DURHAM COUNTY

I-40 and Miami Blvd.

Date: April 4, 2017	County: Durham
Interchange: I-40 and Miami Blvd.	
Location (exit ramp): EB Exit Ramp

I-40/US 421 WB Exit Ramp at NC 66

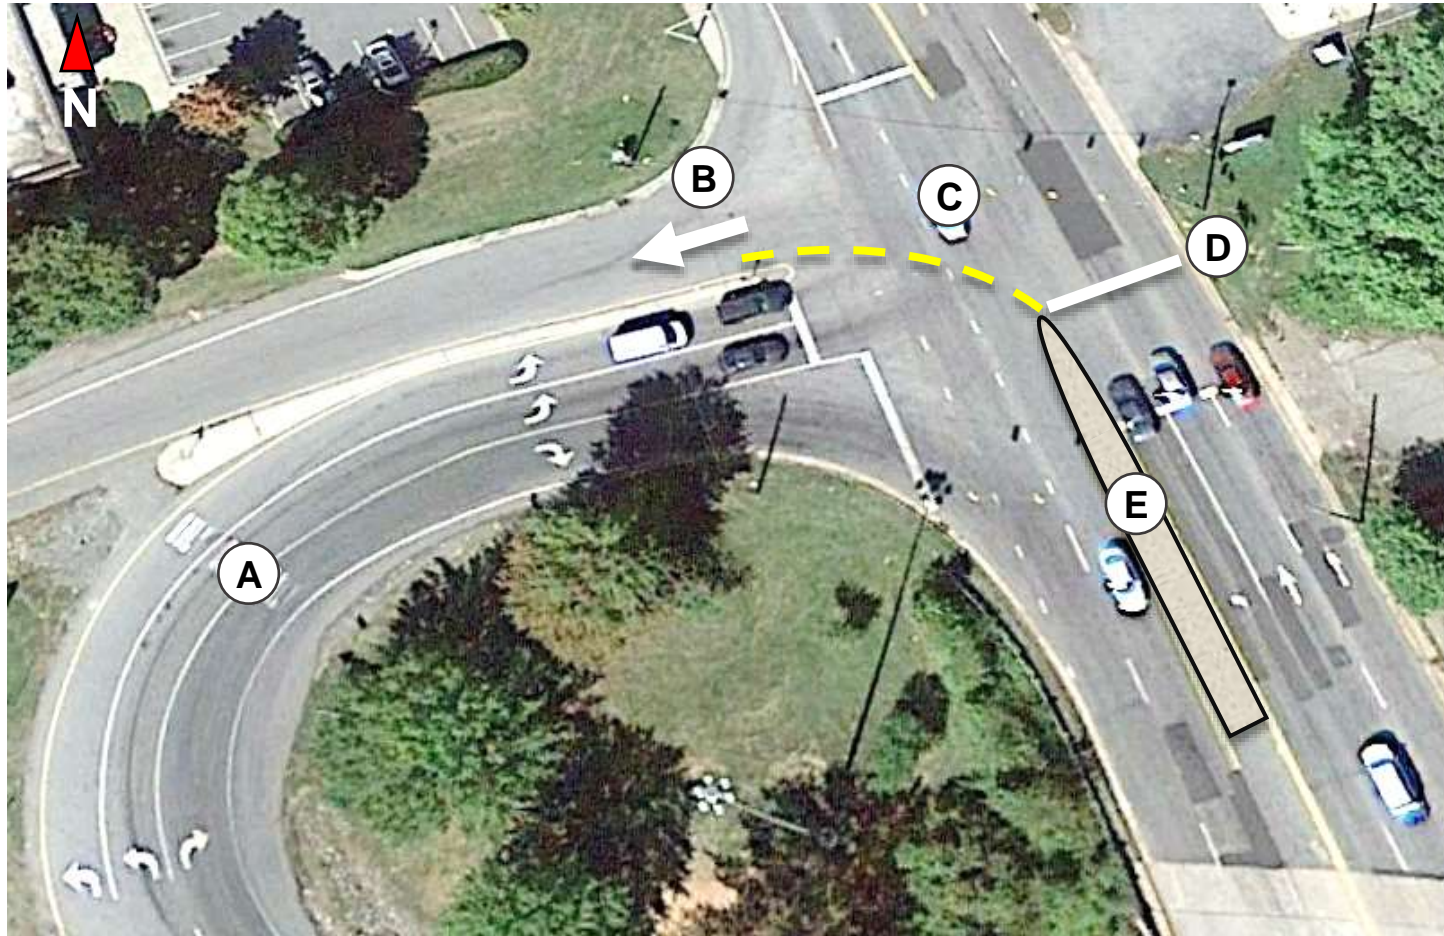
See map for recommendations to move stopping location forward for NB 66 traffic.

- A. Add Wrong Way arrows
- B. Add arrow indicating correct freeway entrance point
- C. Add dotted lane line extension through intersection
- D. Move stop bar forward
- E. Install raised median

US 421 WB Exit Ramp at Lewisville Clemmons Rd.

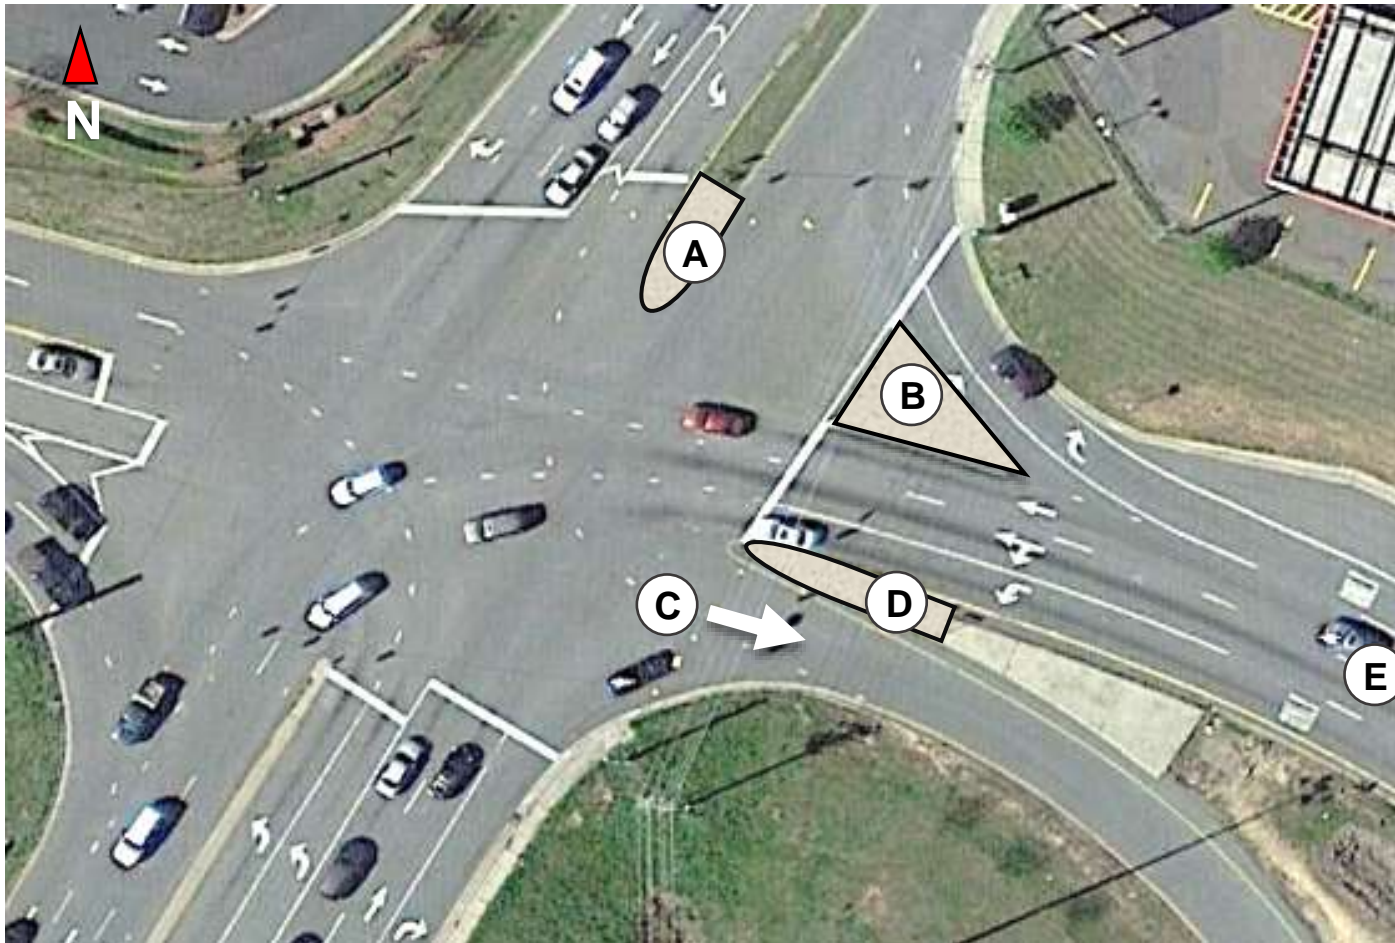
Significant street lighting (4-bulb tall pole) present over entrance ramp area, so additional lighting probably will not help.

- A. Extend median
- B. Convert paint splitter island to raised median
- C. Add arrow indicating correct freeway entrance point
- D. Extend raised median
- E. Add Wrong Way arrows

US 52 SB Exit Ramp at Moore-RJR Rd.

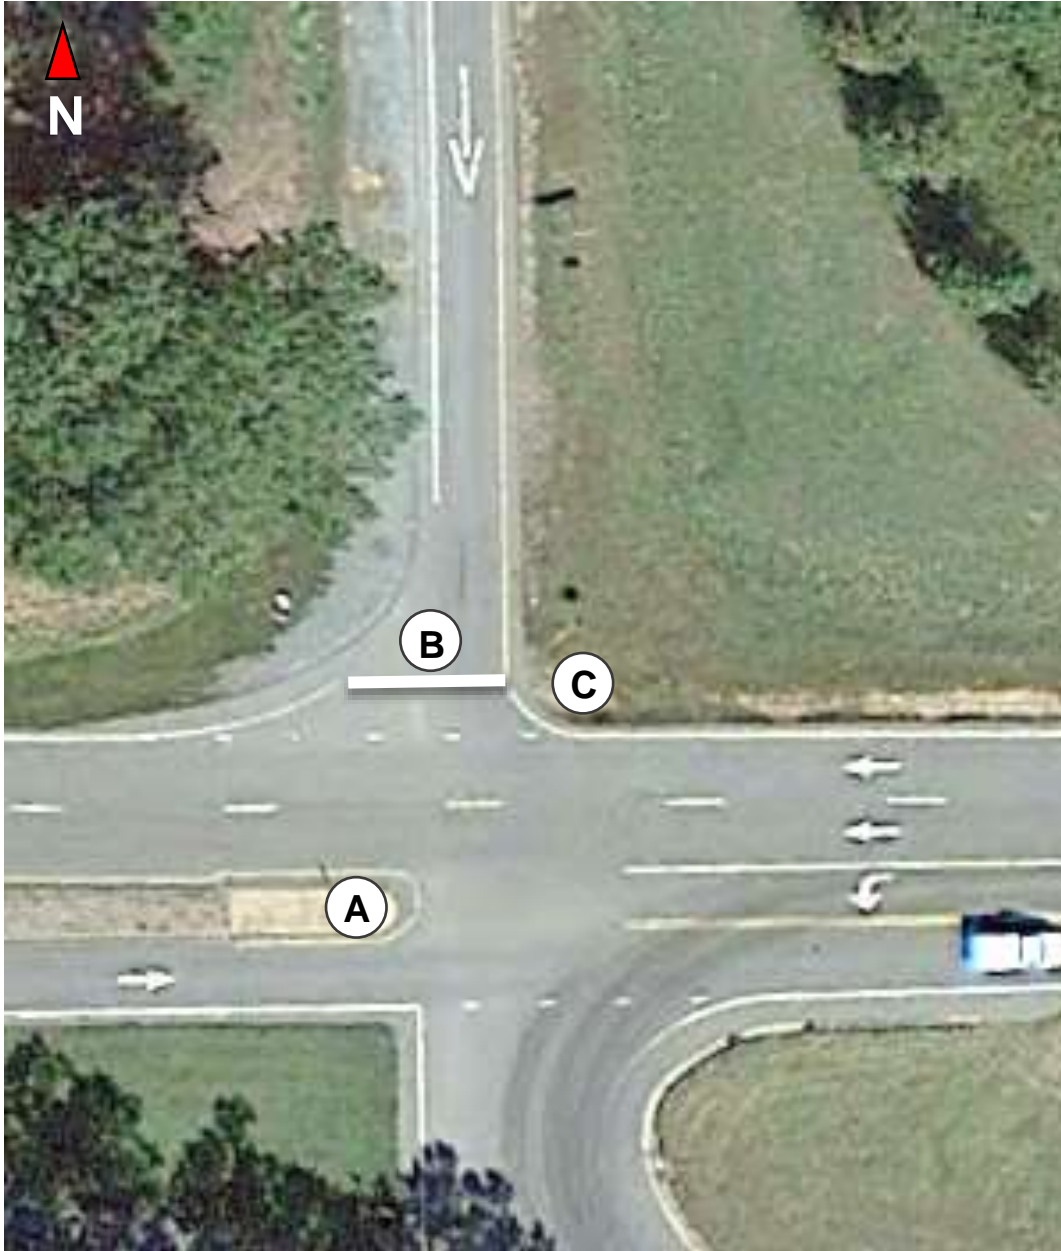
A. Add No Left Turn sign

B. Add stop bar

C. Add No Right Turn

US 52 NB Exit Ramp at Moore-RJR Rd.

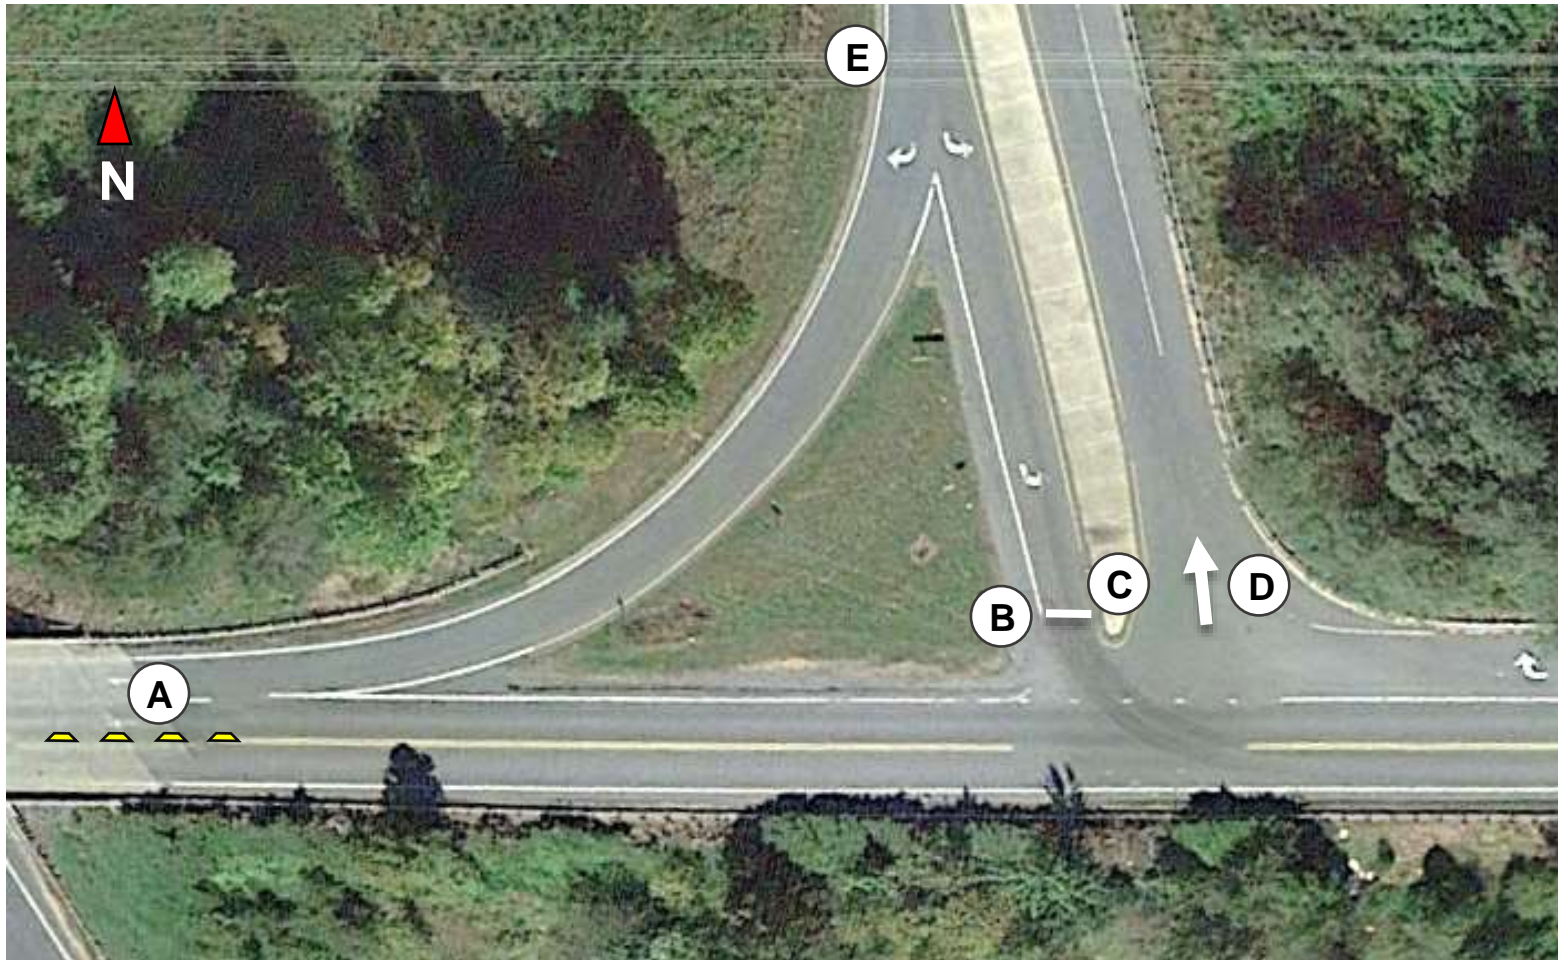
- A. Add flexible median dividers
- B. Add stop bar
- C. Add yellow diamond beneath splitter sign and improve visibility of median
- D. Add arrow indicating correct freeway entrance point
- E. Add Wrong Way arrows

I-40 EB Exit Ramp at Gallimore Dairy Rd.

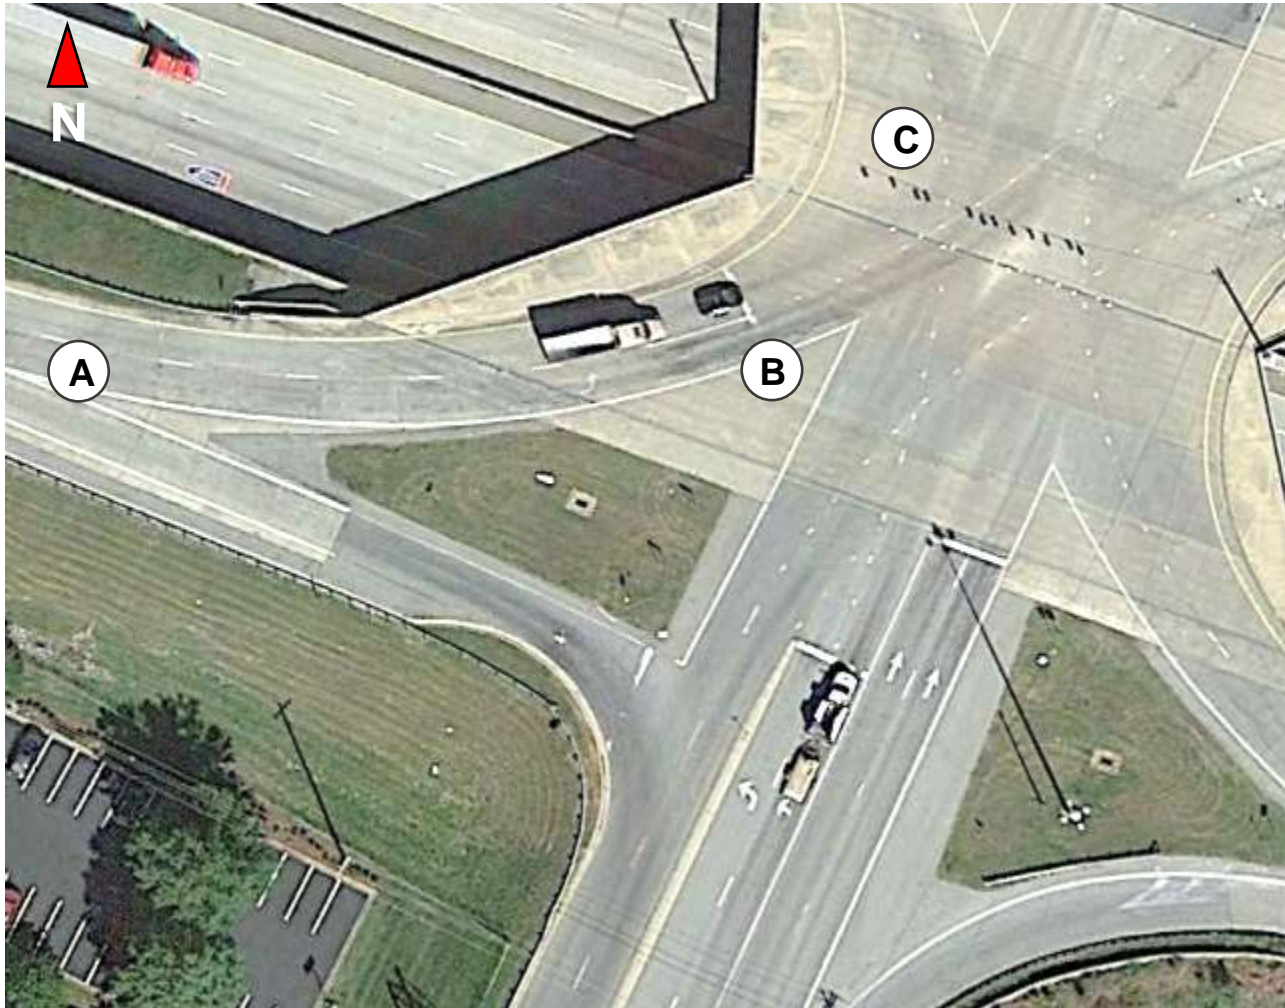
Some form of overhead 'Do Not Enter' sign may be appropriate above the directional lanes of the exit ramp

A. Add Wrong Way arrows

I-40 EB Exit Ramp at NC 68

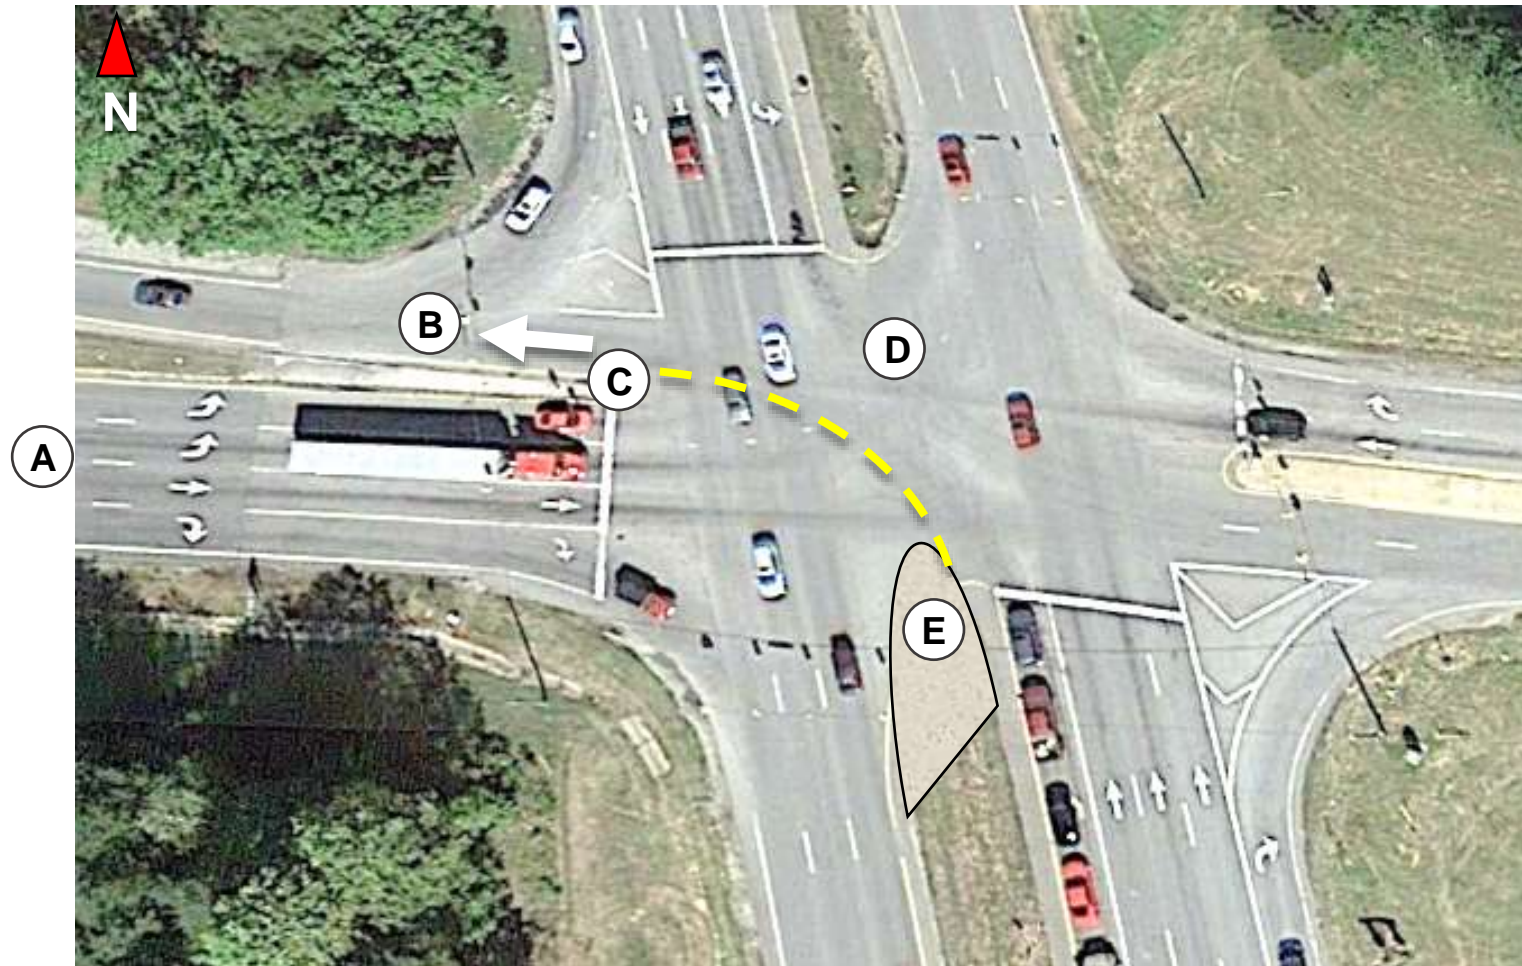
Add guide lines for L-turn onto I-40 EB entrance ramp, adjacent to I-40 exit ramp

- A. Add Wrong Way arrows (not shown)
- B. Add arrow indicating correct freeway entrance point
- C. Add splitter sign on median
- D. Repaint dotted lane line extension through intersection
- E. Extend median / Install raised median

I-40 WB Exit Ramp at NC 68

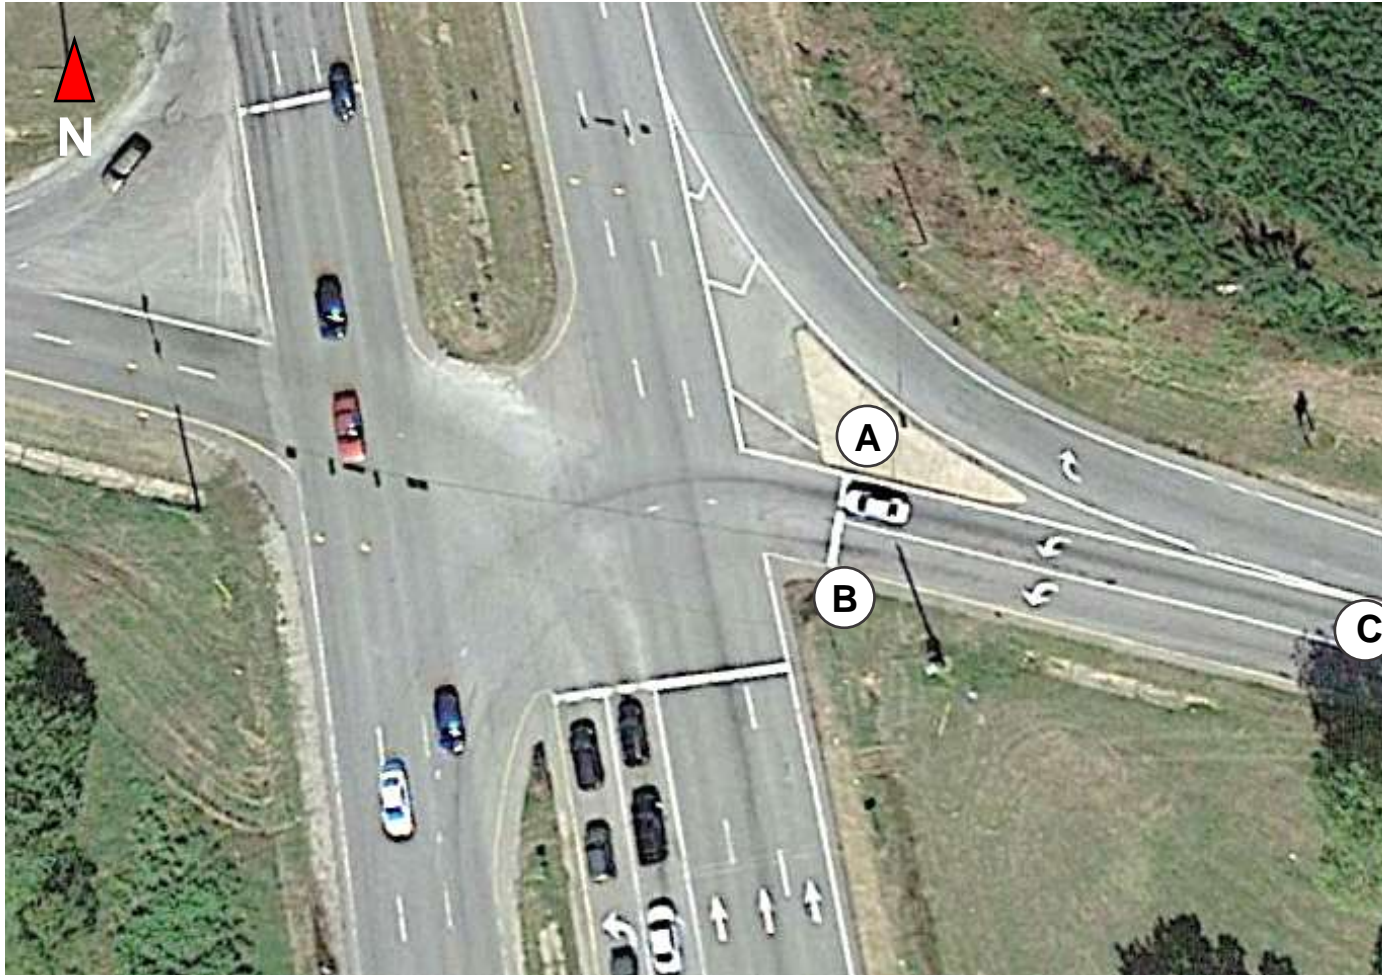
- A. Add One-Way sign
- B. Repaint stop bar
- C. Add Wrong Way arrows

I-40 and EB Exit Ramp and Rock Creek Dairy Rd.

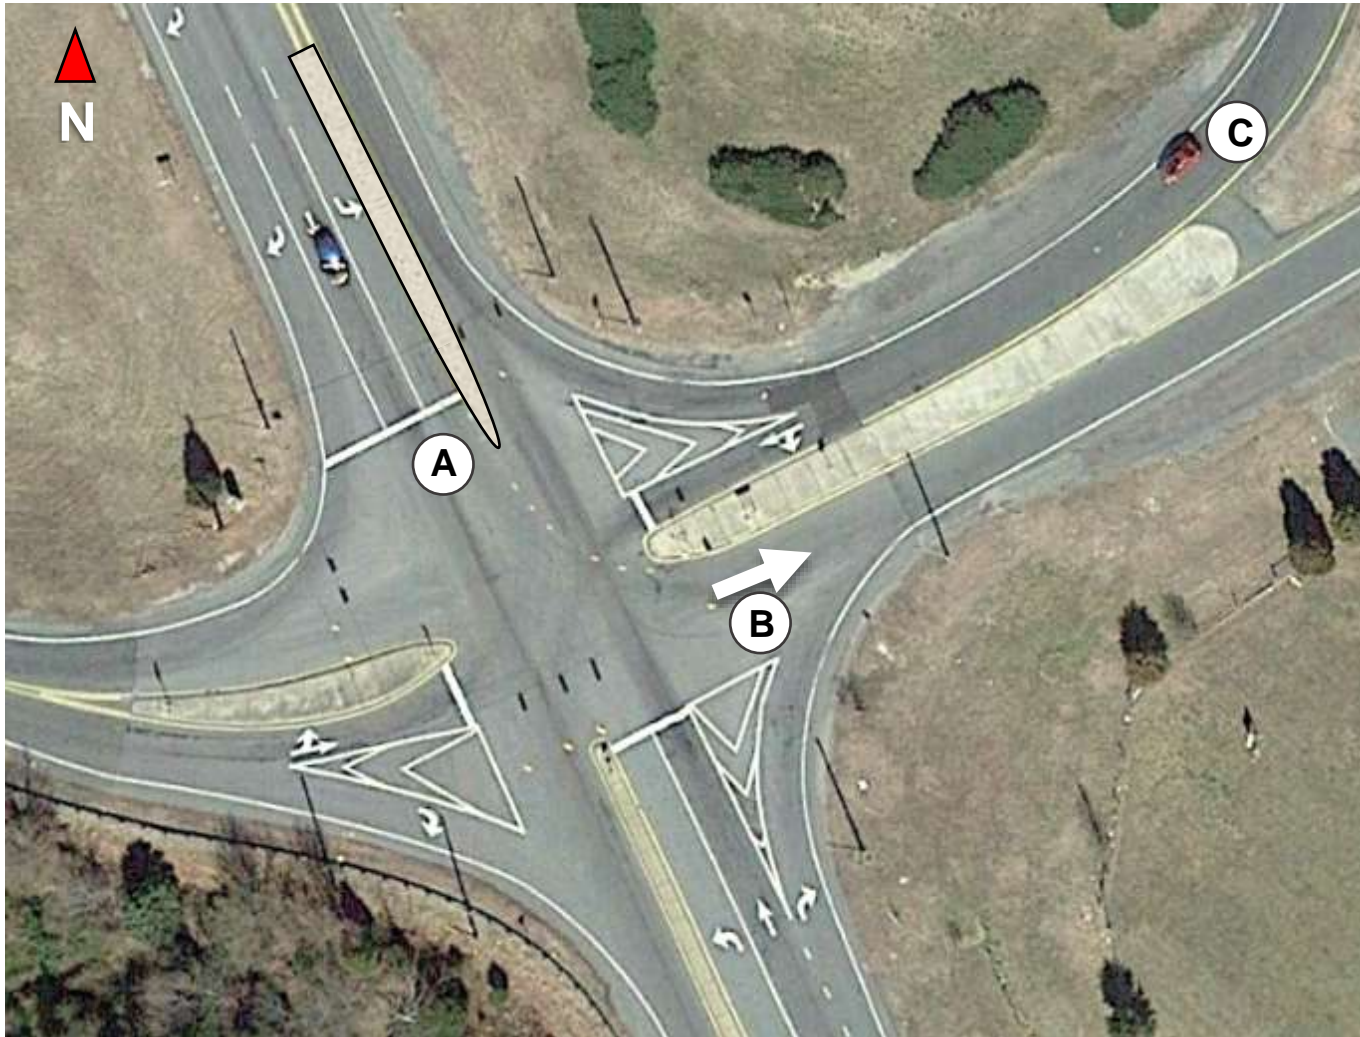
A. Install raised median

B. Add arrow indicating correct freeway entrance point
